Radio Controls Inoperative At Cold Temperatures

Service Category Audio/Visual/Telematics

YEAR(S)	MODEL(S)	ADDITIONAL INFORMATION
2016	Highlander

Figure 2.

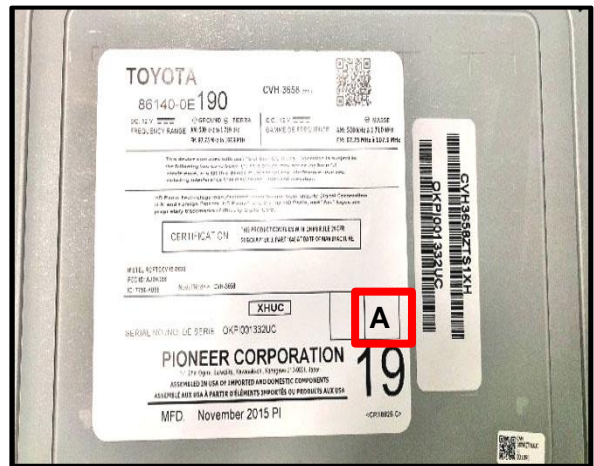
- Inspect the head unit label on top of the head unit to verify post countermeasure marking.

Is there a character in the indicated area?

- YES** — This bulletin does NOT apply. Continue diagnosis using the applicable Repair Manual.
- NO** — Go to step 5.
